UWCD Model Peer Review

Peer Review of the United Water Conservation District and Calleguas Municipal Water District Models for the Oxnard Subbasin, Pleasant Valley Basin, and Las Posas Valley Basin

Fox Canyon Groundwater Management Agency

MARCH 2019

Figure 8-6 Recharge (in/year) for January, 1970

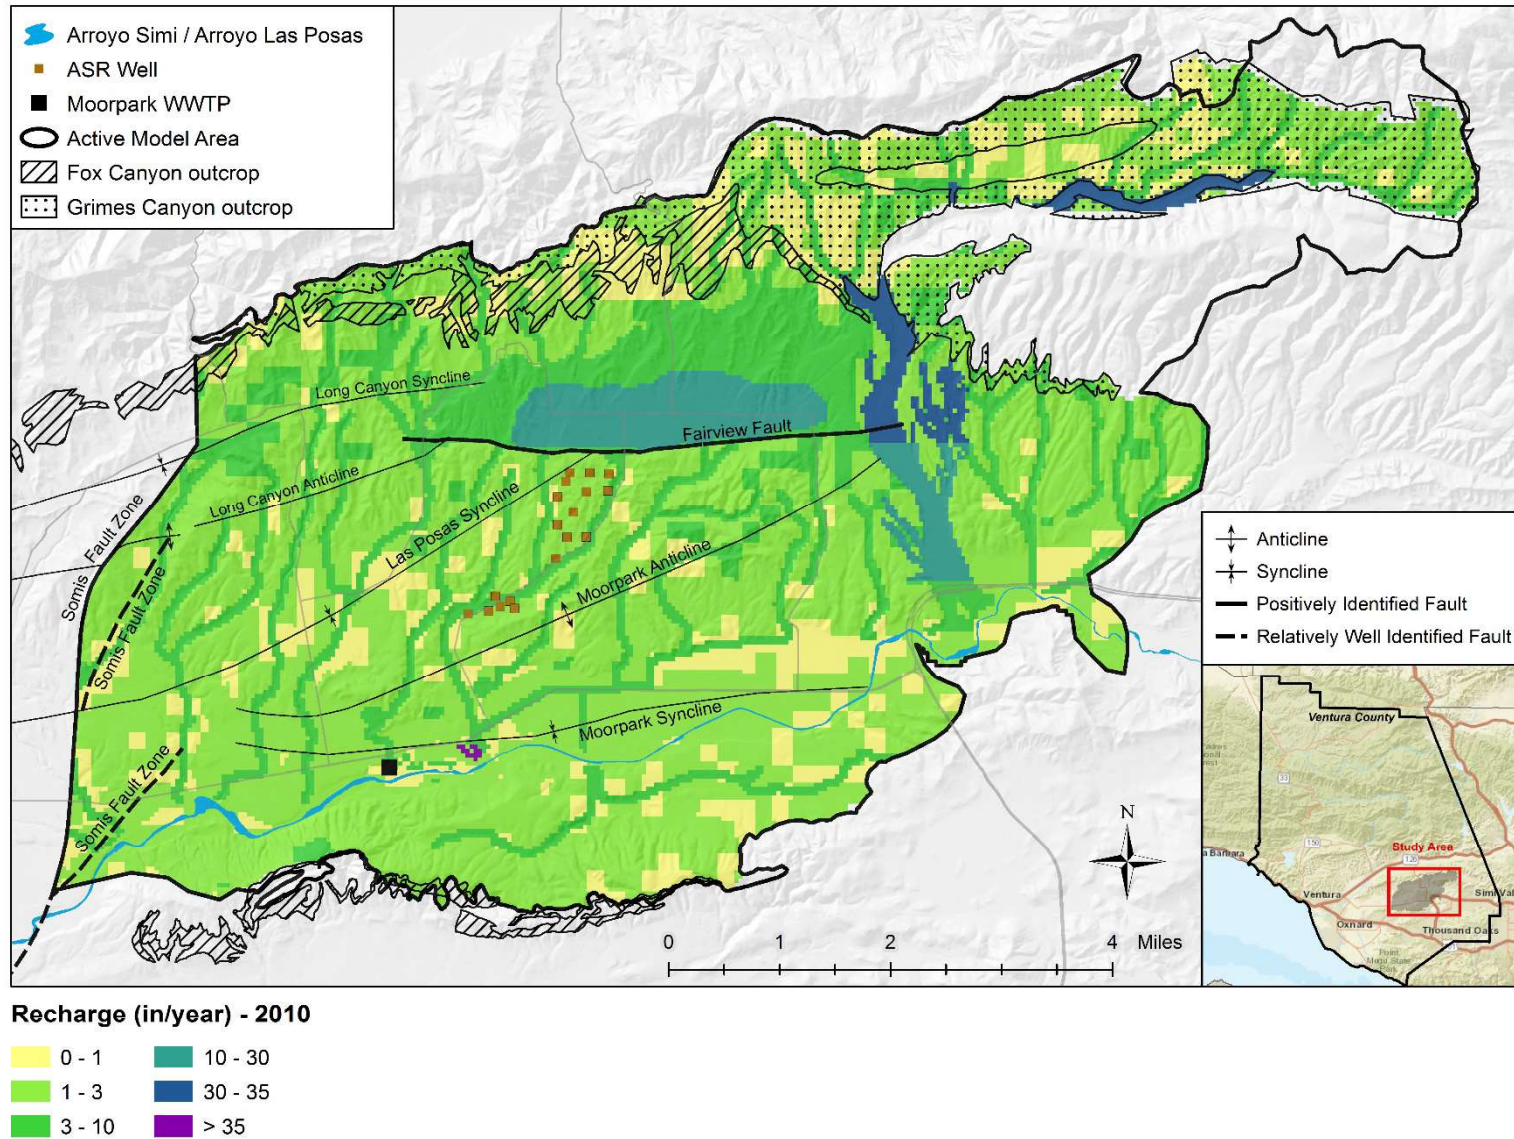
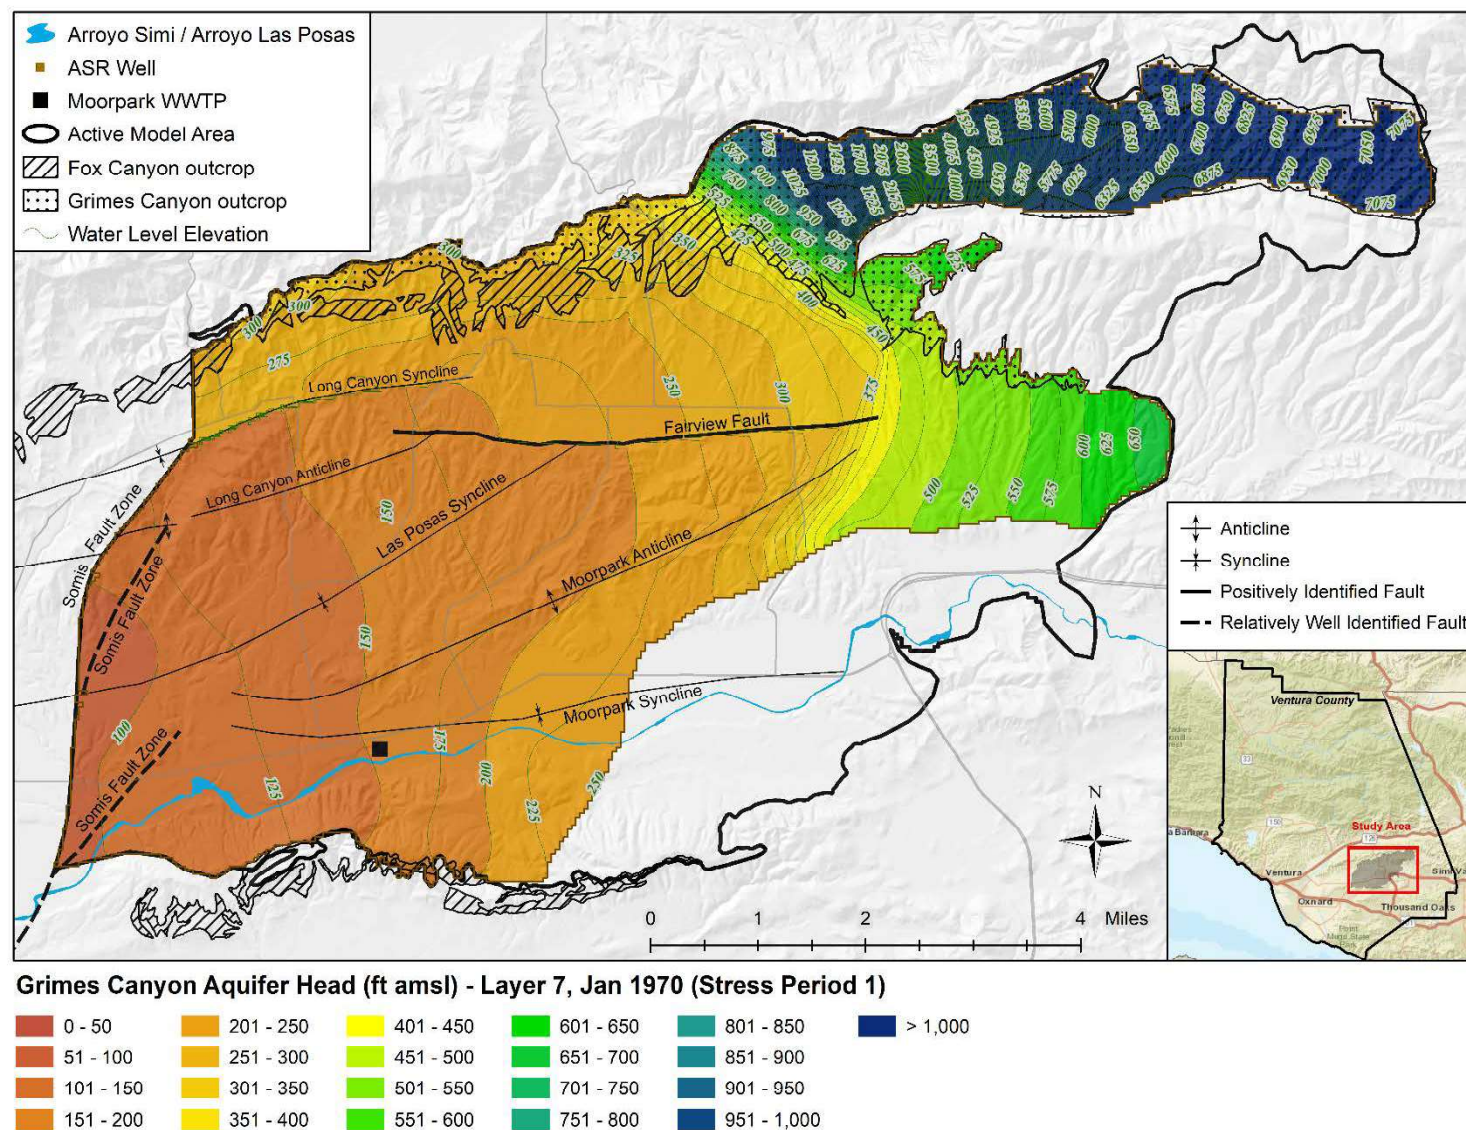
The model incorporates recharge to the Grimes Canyon aquifer in the outcrop area in the northeastern portion of the model. CMWD Figures 8-6 and 8-7 in Appendix B show parts of the outcrop area where drainage channels receive 30-35 inches per year of recharge. There are no stream gauges in this area, nor wells to constrain this assumption. There is also no data to guide the assumed thickness of the Grimes Canyon aquifer in this area. Simulated heads in this area of the model rise from initial heads of 1,000 to 7,000 ft msl (CMWD, 2018: Fig. 8-55) in January 1970 to 1,000 to 14,500 ft. msl in January 1990 to 1,000 to 22,000 ft msl in January 2015. Simulations of future conditions produce heads of approximately 29,000 ft msl. While these simulated heads are unrealistic, different assumptions about aquifer thickness and specific storage could change them dramatically.

The parameterization of the GCA outcrop area merits revision.

Figure 8-7 Recharge (in/year) for January, 2010

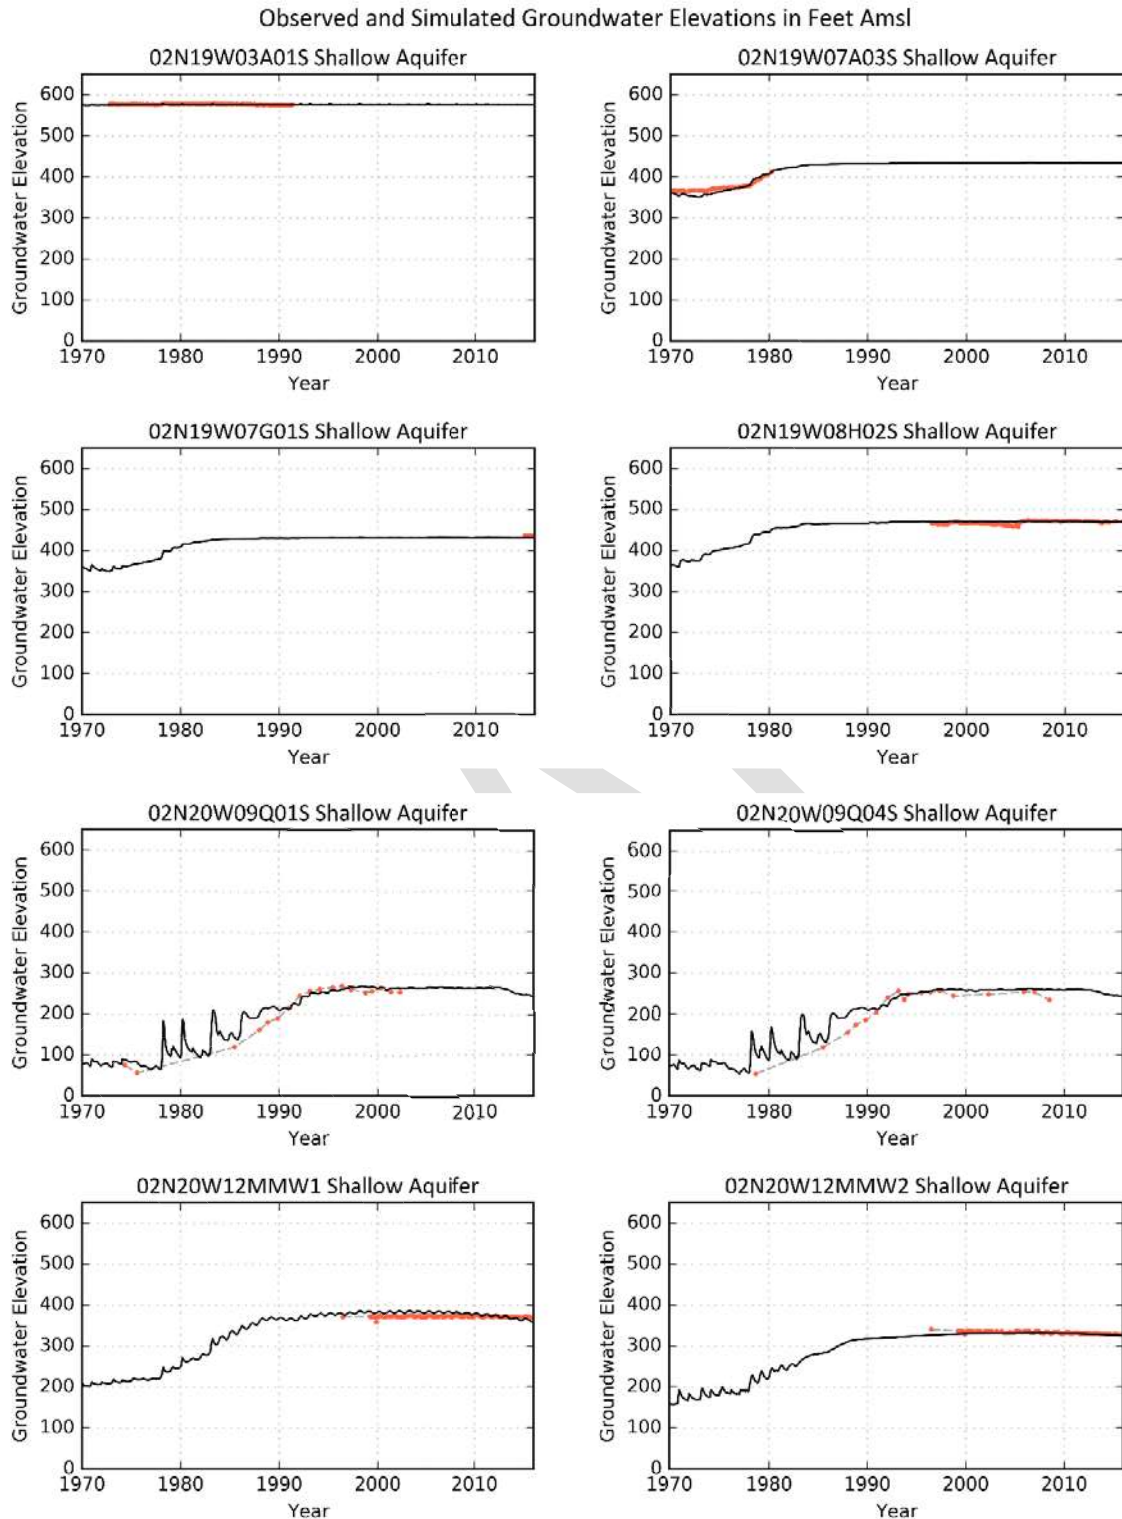
Examining the historical production from the Grimes Canyon Aquifer and the modeled impacts of the excessive predicted heads in the Grimes Canyon Aquifer, the uncertainty regarding modeling of the entire ELPMA is small. Over the next 5 years, hydraulic properties and recharge to the Grimes Canyon aquifer in the outcrop area should be investigated to constrain the estimated recharge. Geochemical evaluations might be useful in this regard.

Figure 8-55 Layer 7 (GCA) hydraulic heads (ft amsl) – Jan 1970 (Stress Period 1)

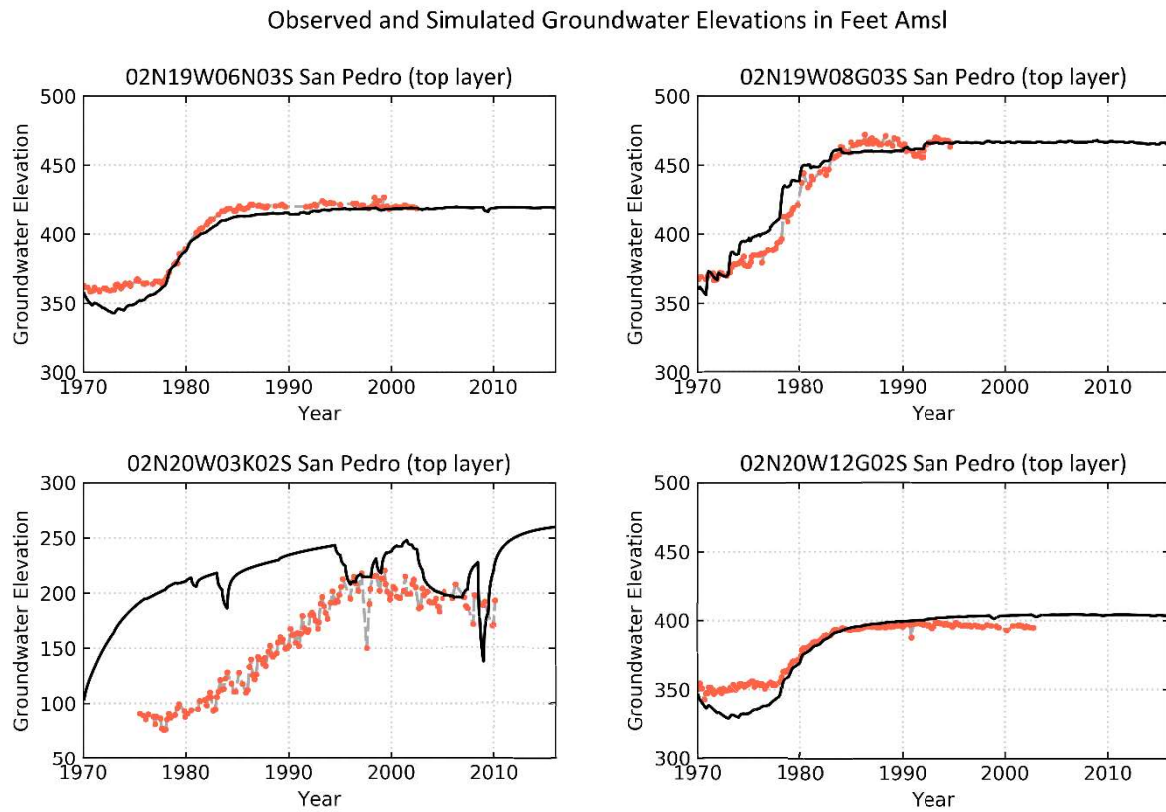
The model reproduces historical groundwater levels well in the shallow aquifer, USP, Fox Canyon, and Grimes Canyon aquifers in the central and southern portions of the ELPMA (See for example wells 02N20W09Q01S and 2N20W09Q04S on Figure 8-58, Figure 8-60, wells 02N20W09R01S, 02N20W10D02S, 2N20W10G01S, and others in Figure 8-62b, and 03N20W35R02S and 03N20W26R03S in Figure 8-63 – of the CMWD Model Documentation Report; also included as attachments in Appendix B). Simulated groundwater levels in the northern and northwestern area are not reproduced as well. There were fewer historical observations and greater uncertainty regarding well screens and the aquifers tapped by wells in the northwest. Simulated heads in Well 3N20W27B01S are a couple of hundred feet lower than observed (Figure 8-63 from the CMWD Model Documentation Report and included in Appendix B). Consequently, predictions of groundwater levels under future conditions are much less certain in the northwest of the ELPMA than they are in the center of the basin.
